**AEGIS LIVING**  
RECOMMENDATION MEETING

25 JANUARY 2016  
DPD #3018400

ADDRESS: 8511 15TH AVE NE  
DPD PROJECT #: 3018400

1. ARCHITECTURAL CONTEXT AND STYLE

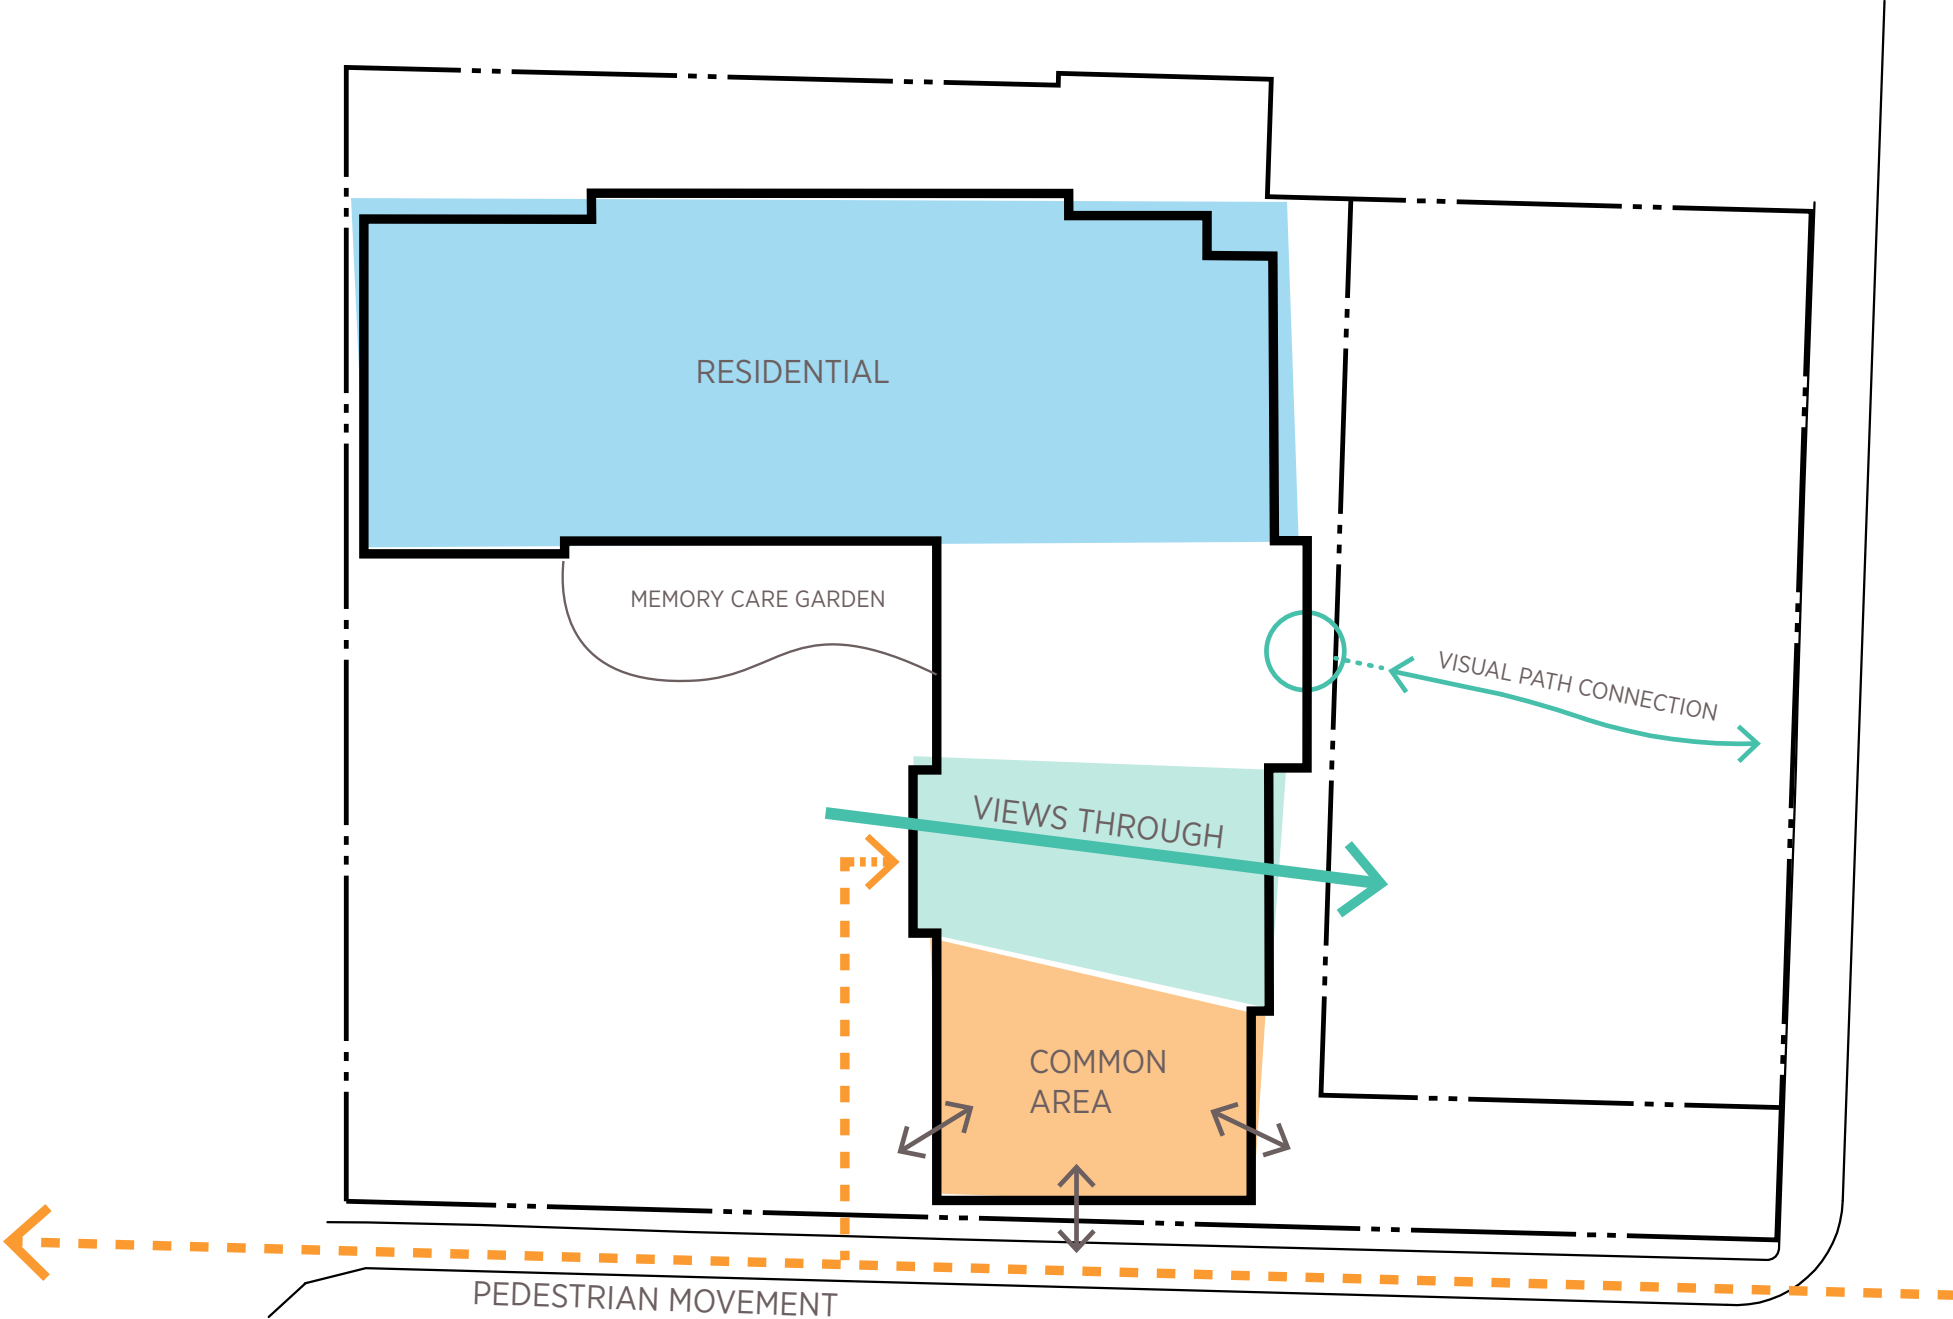
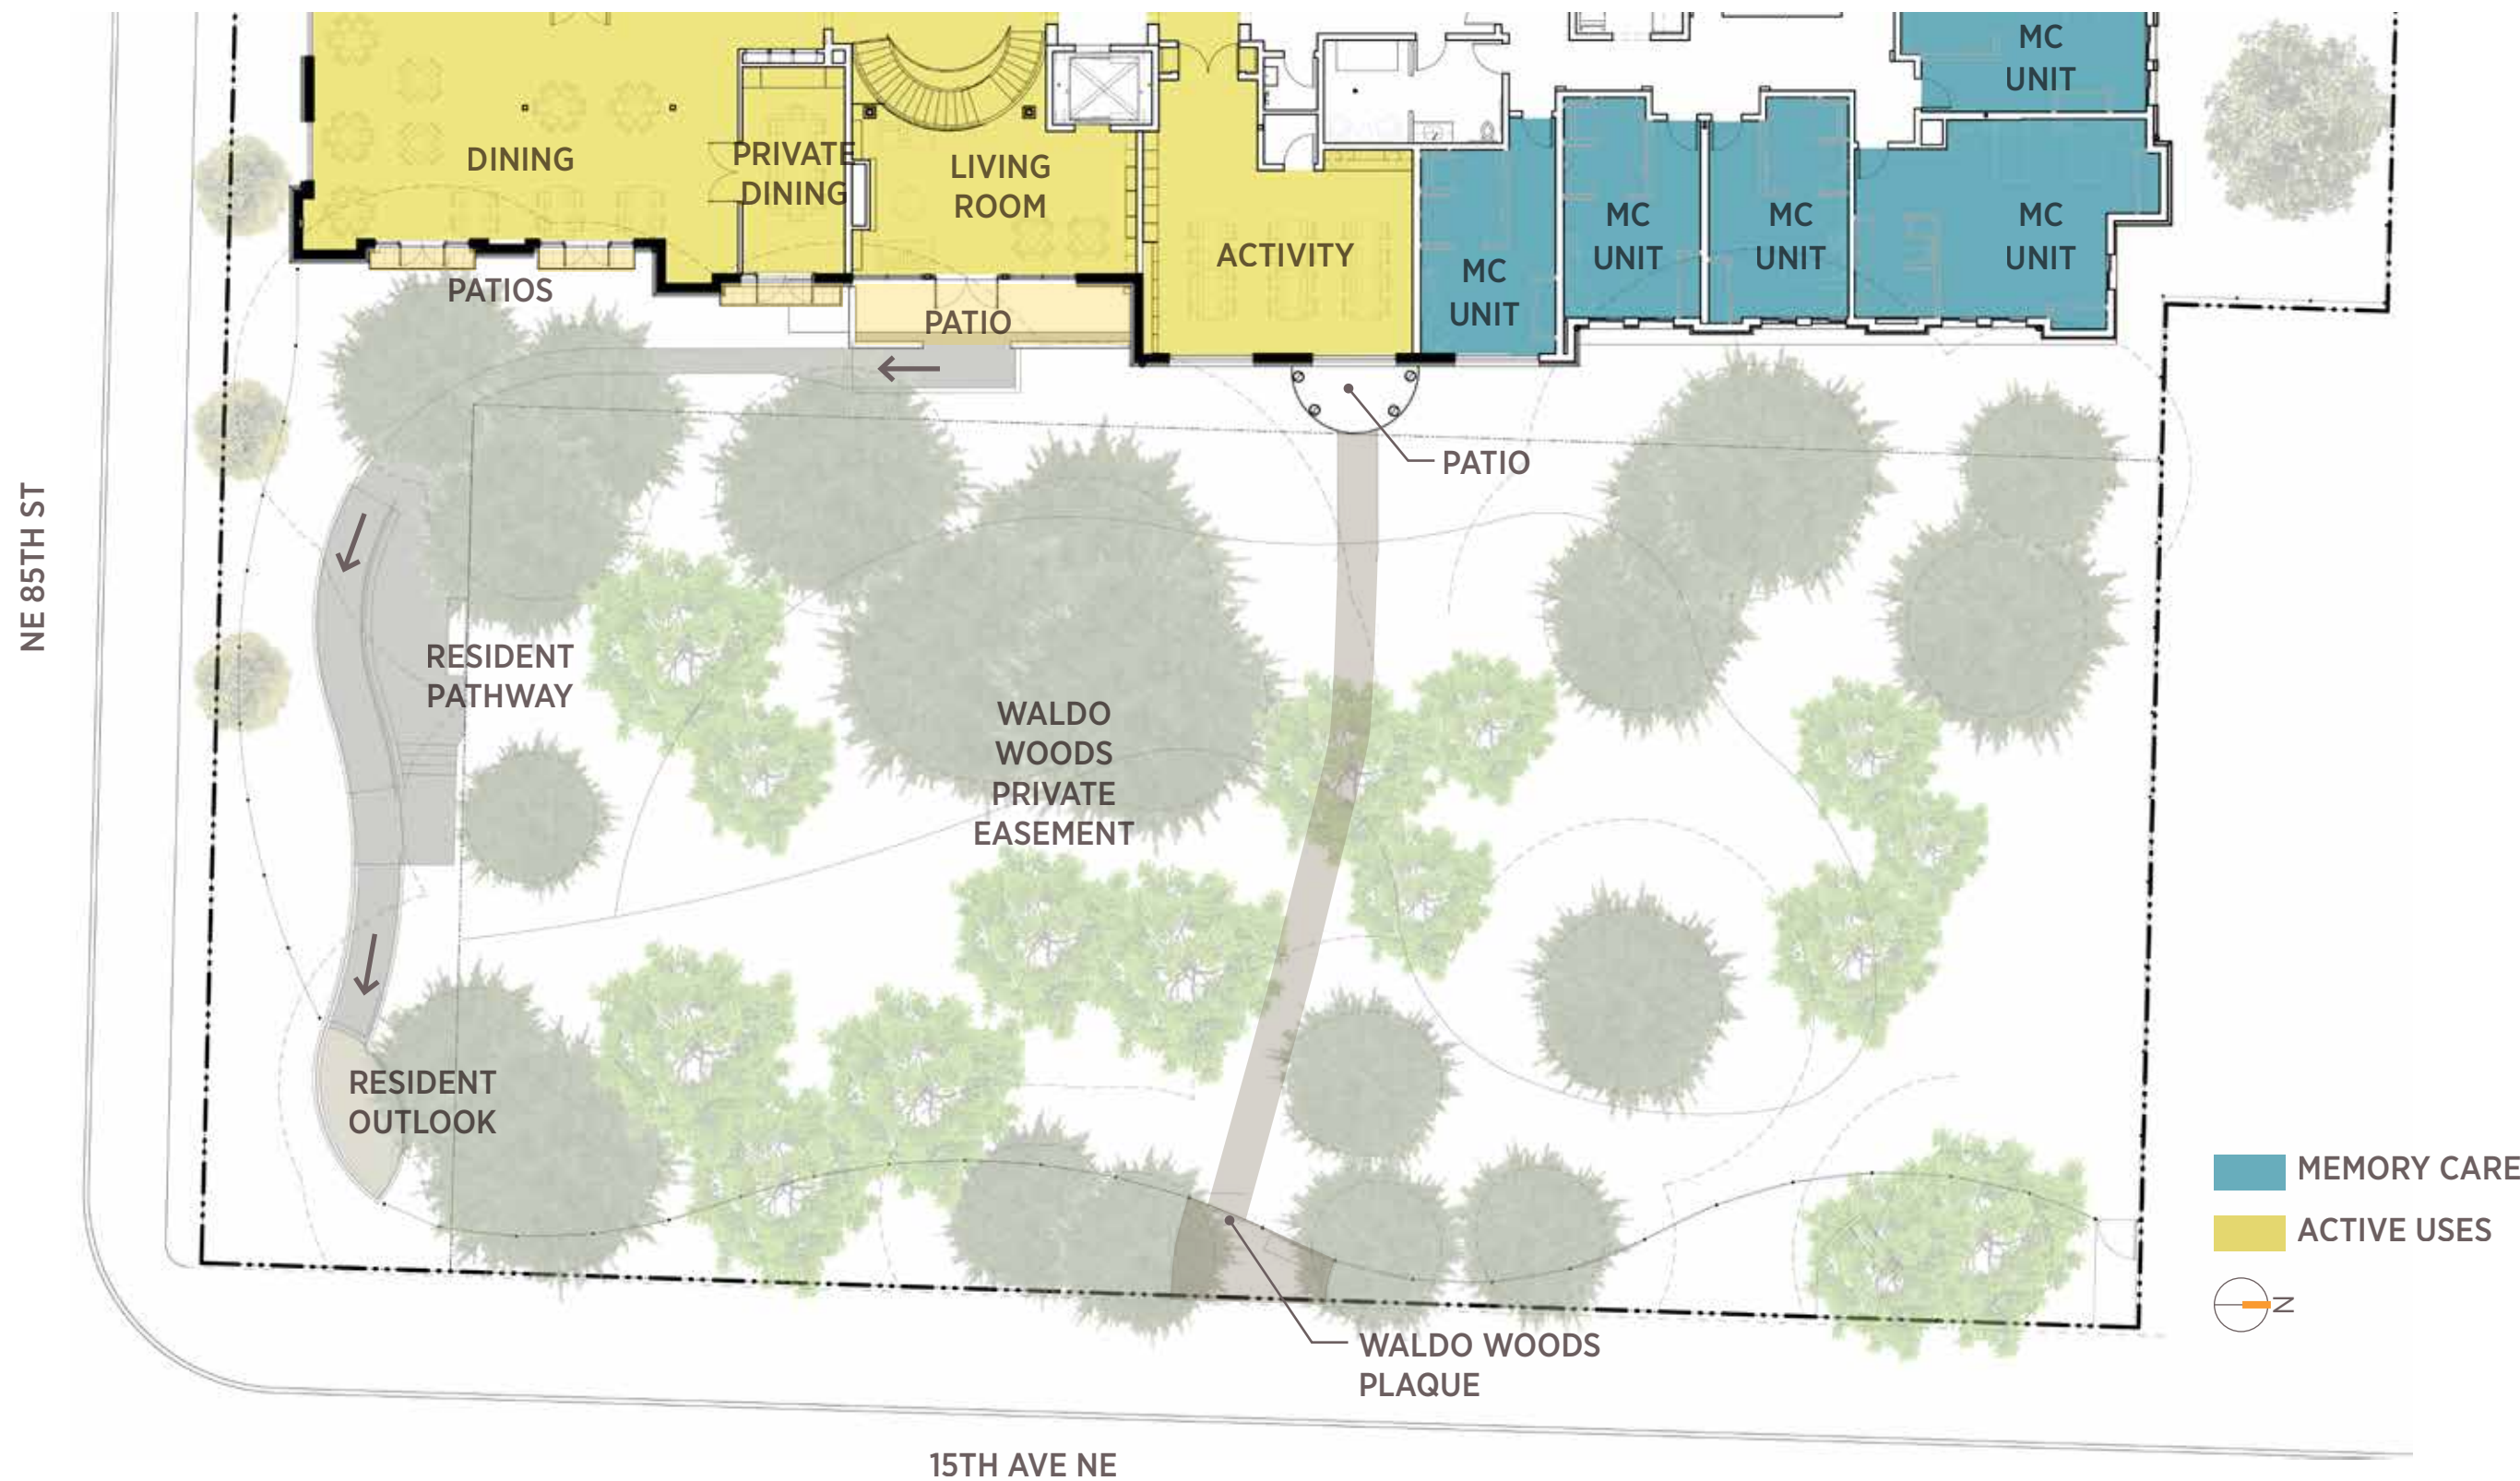
DRB RECOMMENDATION  
(PL1-B-1, PL2-A&B, CS3-A-4, DC1, DC2, DC4, CS2-D)

The Board noted that active uses within building need to be aligned with the existing eastern wooded area of the site. Interior functions might spill out into outdoor space. The Board was supportive of a Neo-classical design for the site. The Board agreed that the Massing Study C reads well as an institution.

The most active rooms in the building are the social spaces such as the dining room, living room and multipurpose activity rooms. We have focused those spaces along the West, East, and South facades along the southern half of the building, bringing those spaces into closest proximity to 85th Street.

Specific to the 'Waldo Woods' to the East, the Lobby and Living Room enjoy views through the building and along the historical path leading to the building. Active spaces such as dining rooms and activity rooms also face the woods and spill out onto patio spaces allowing further engagement. The patio from the living room leads to a path which allows residents to safely access the Southeast corner of the site. Per the easement agreement with the Seattle Parks Department, there are no improvements, including paths, within the conservation easement.

2. COLORS AND MATERIALS

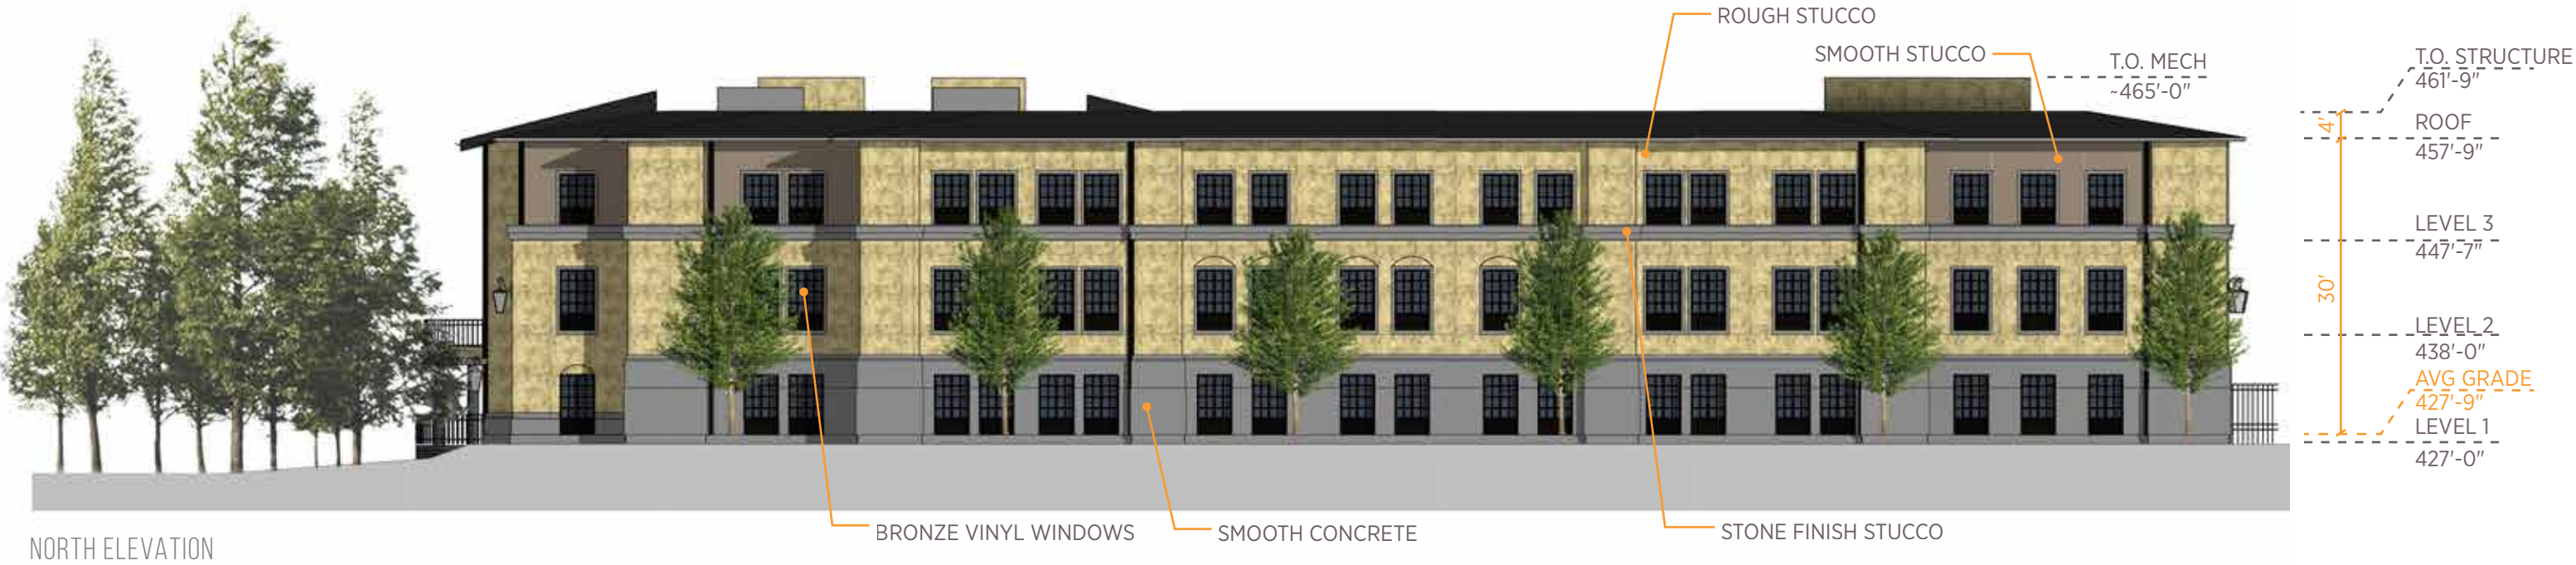
DRB RECOMMENDATION  
(DC2-D, DC4-A, PL2-B, CS3-A)

- 1. The Board recommended high quality elements, architetur al features, details, and finishes. Human scaled elements should provide a strong connection between the project and the public realm.
- 2. The design should set a context of visual interest and human scale for all four facades.
- 3. Regarding blank walls, it is recommended that any blank walls should include design treatments of high quality elements and finishes to respond to human scale and visual interest.

- 1. In keeping with the simple and traditional theme of the design, the primary cladding for the building is a rough textured stucco in a yellow-earthen tone which complements its surroundings and brings additional depth to the massing moves. This is a high quality, hand finished 3 part cement stucco which will retain its look for many years. At the main entrance this stucco finish is accented with a GFRC (Glass Fiber Reinforced Concrete) base which adds additional depth and articulation. Stone clad columns at the perimeter of the site add an additional layer of texture and depth to the design.

- 2. The materials presented create a variety of tones and textures, and are applied to give the building a perceivable human scale. By emphasizing the base of the building and allowing the top floor to recede with darker color and less texture, the overall perception of mass is reduced.

- 3. Other than a well articulated and curving landscaping wall which contains the memory care garden, the building has no blank walls - all of the facades contain windows, lights, and other features.

3. STRUCTURE ORIENTATION/LOCATION, MASSING, AND SITE RESPONSE

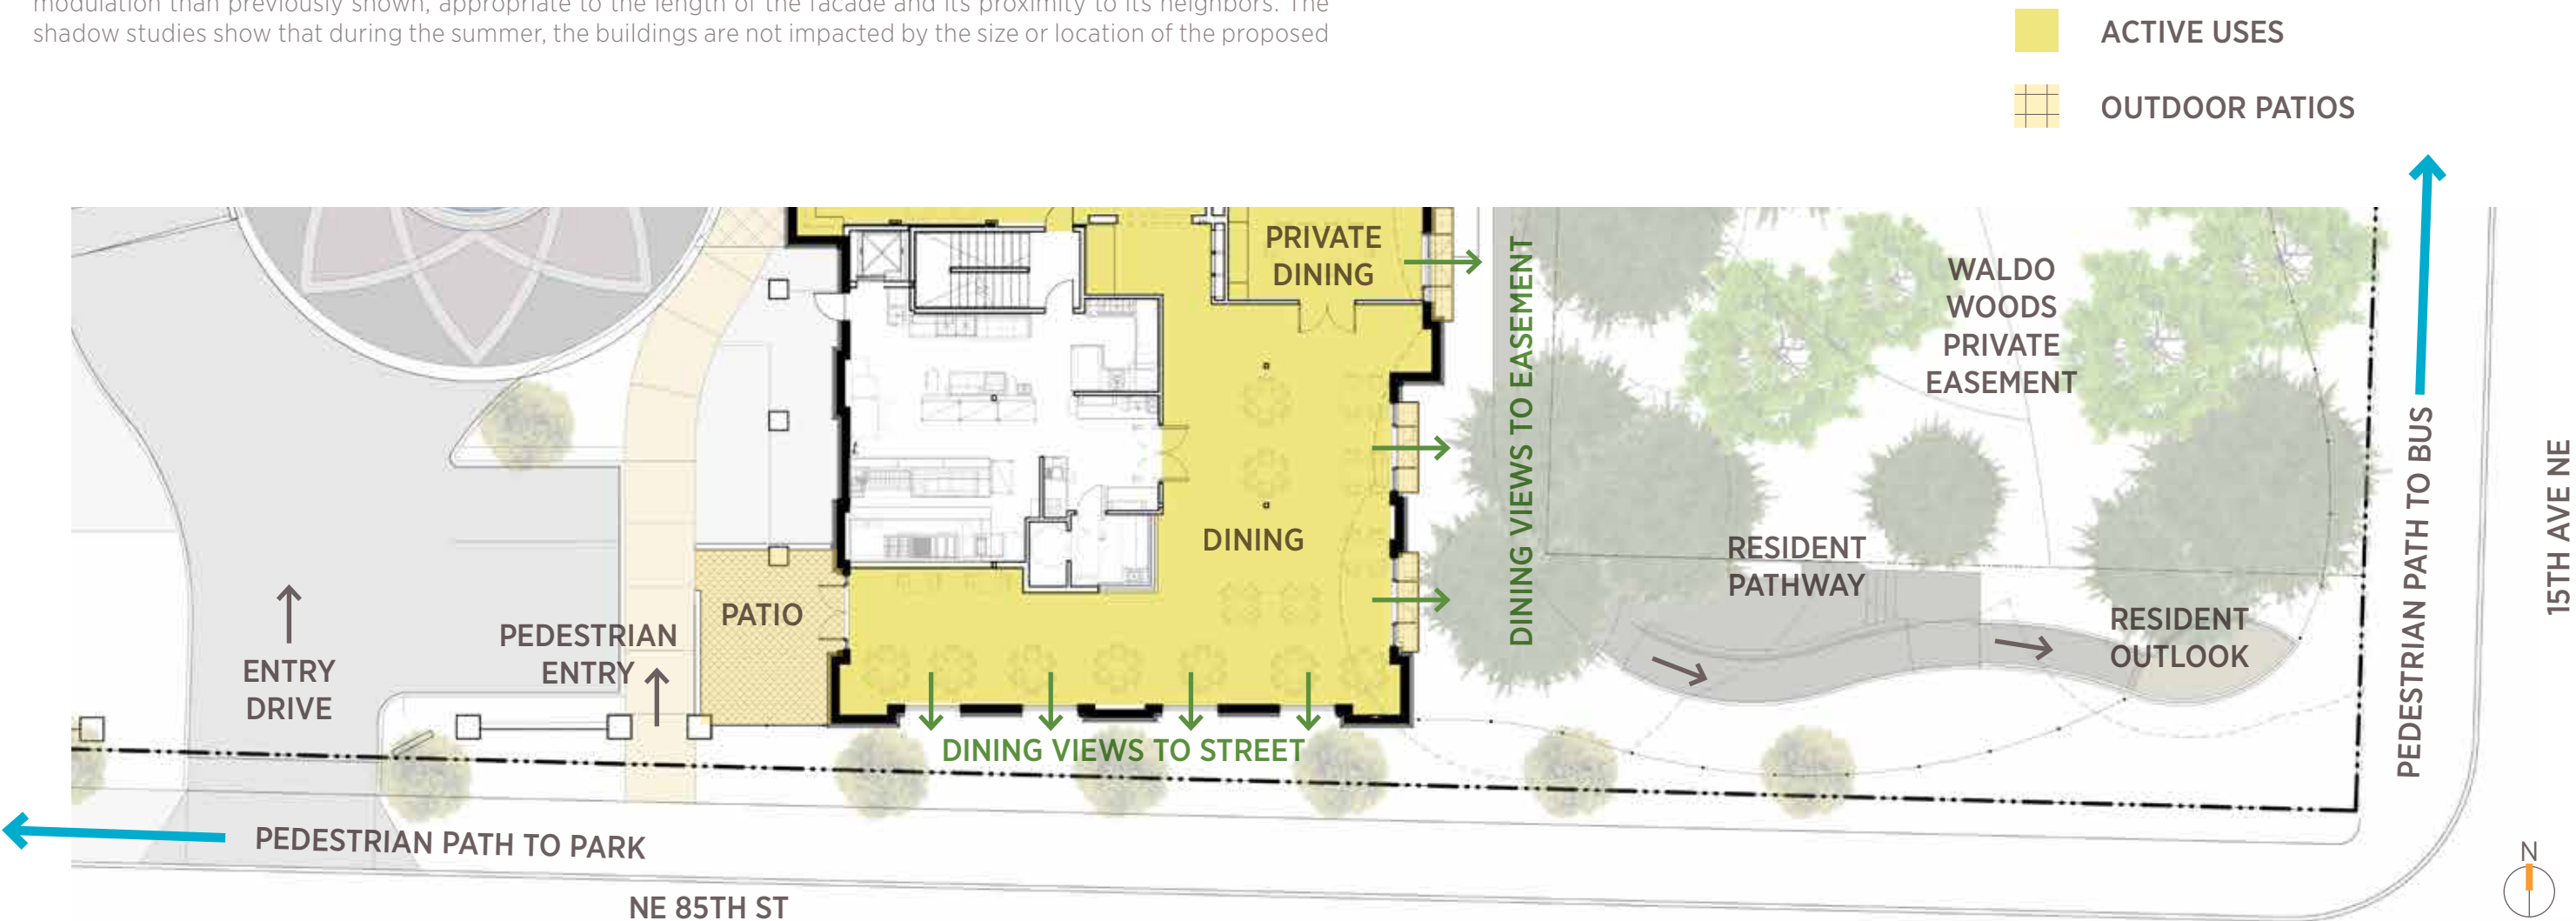
DRB RECOMMENDATION

- 1. The Board suggested more and deeper modulation on the North facade. Provide shadow studies that demonstrate that casting shadows on neighbors is minimized. The board recognized the concern for lost views; however their purview does not include protection of views from private property.
- 2. The pedestrian experience along NE 85th St and the Southern facade needs to be given special consideration.
- 3. DPD requests a privacy study documenting the visual relationship between the proposed facade fenestration and adjacent sites.

structure. Although the winter sun casts the south face of the townhomes to the north in shadow, we believe that almost any structure within the allowed height and FAR would do the same.

- 2. Pedestrians entering or exiting the Maple Leaf Reservoir will enjoy views of interior and exterior spaces inhabited throughout the day and evening, and residents in the building will have an opportunity to engage in the activities just outside their front door. Residential spaces located along the main massing of the building that abuts the adjacent LR2 residential lots. Architectural connection at the East side of the building to welcome the historical path. The common areas of the building maintain a visual connection with pedestrian movement along 85th. The center section of the building connects the two open spaces of the site. The main entrance courtyard has a visual connection through the center of the buildnig through to the historical tree easement, also known as the "Waldo Woods."
- 3. The study requested has been provided on the following pages.

- 1. The diagrams on the following pages demonstrate that the North facade has much deeper and more frequent modulation than previously shown, appropriate to the length of the facade and its proximity to its neighbors. The shadow studies show that during the summer, the buildings are not impacted by the size or location of the proposed
